IBC — Fire Safety

2021 GROUP A PROPOSED CHANGES TO THE I-CODES

April 11 – May 5, 2021
Virtual Committee Action Hearings

2021 GROUP A – PROPOSED CHANGES TO THE INTERNATIONAL BUILDING CODE – FIRE SAFETY

Figure 1B: Example detail for Type III-A exterior wall-floor intersection with two rim boards

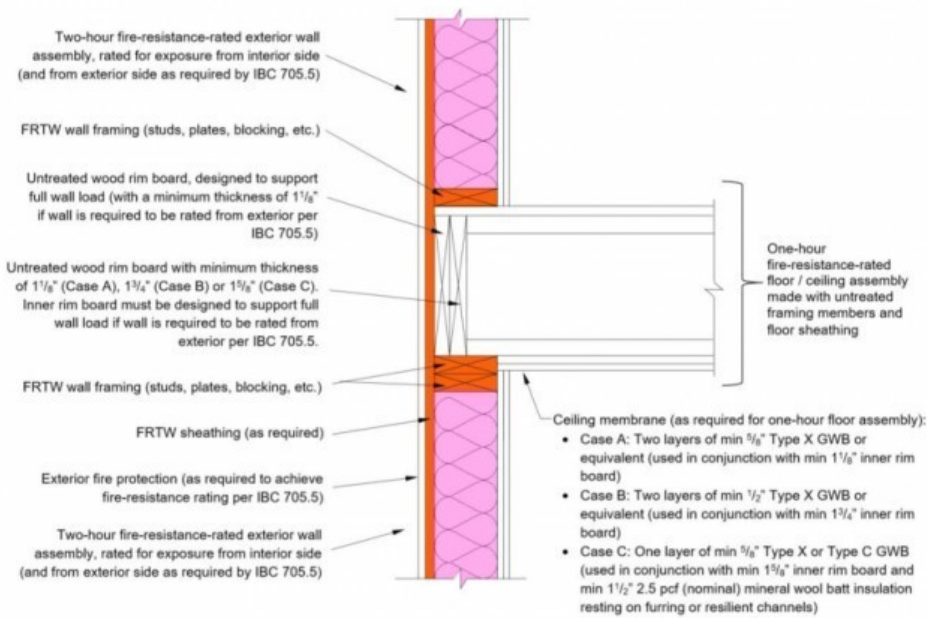
The current code language is subject to multiple interpretations, including requiring the floor elements to be fire-retardant-treated or prohibiting platform details altogether. These interpretations are costly and do not serve to increase safety. Often, they may jeopardize the fire performance of the floor for the sake of protecting the wall. The proposed subsections will clarify the issues, encouraging a practical and effective approach without compromising fire resistance or safety.

Fire-resistance for exposure from exterior side (where required per IBC Section 705.5): A combination of exterior fire protection, FRTW sheathing, and minimum 1¹/₈-inch-thick outer rim board is used to provide two hours of protection to the inner rim board. Layers to the exterior of the outer rim board (e.g., exterior fire protection, FRTW sheathing, etc.) must be sufficient to provide at least 80 minutes of protection to the outer rim board. The inner rim board must be designed to support the load from the wall above.

FIGURE 722.5.1(2)
GYPSUM-PROTECTED STRUCTURAL STEEL COLUMNS WITH SHEET STEEL COLUMN COVERS

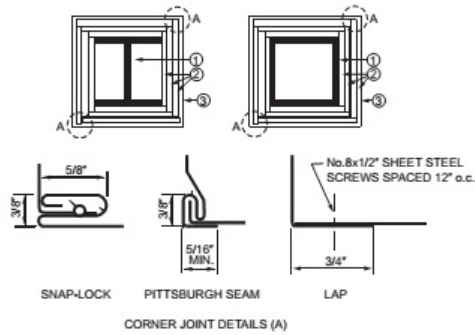
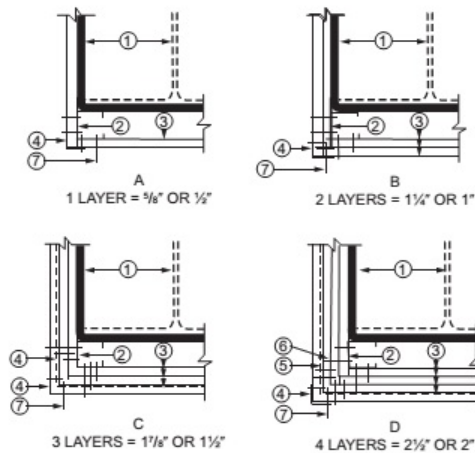
IBC: FIGURE 722.5.1(2), FIGURE 722.5.1(3), 722.5.1.2.1

Revise as follows:

722.5.1.2.1 Attachment. The gypsum board or gypsum panel products shall be supported as illustrated in either Figure 722.5.1(2) for fire-resistance ratings of 4 hours or less, or Figure 722.5.1(3) for fire-resistance ratings of 3 hours or less.

FS 142-15 Figure C
Proposed Code Change

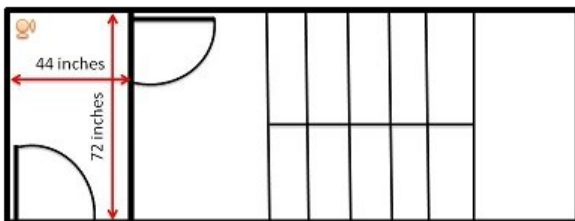
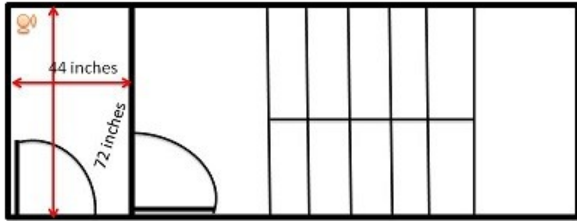
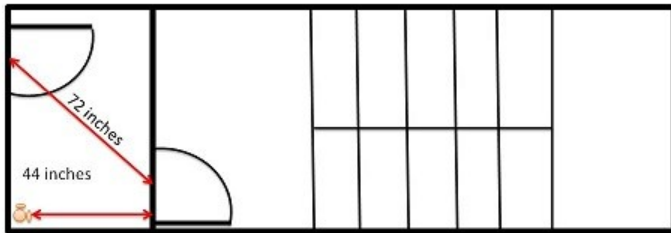
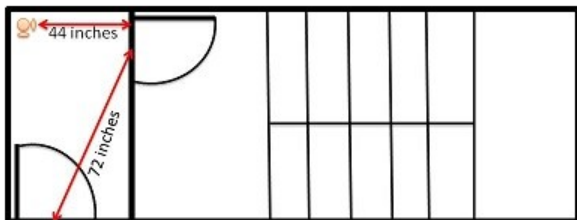
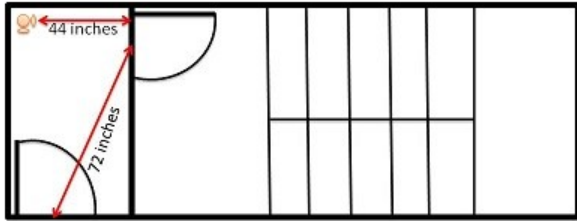
The code change also requires that the 44 inch width be a clear width for consistency with the requirements in Section 1003.3.3 in the event a standpipe is placed within the vestibule or pressurization ductwork is located within the vestibule.

We hope that the Fire Safety can approve this clarifying code change that is reflective of current practice in California.
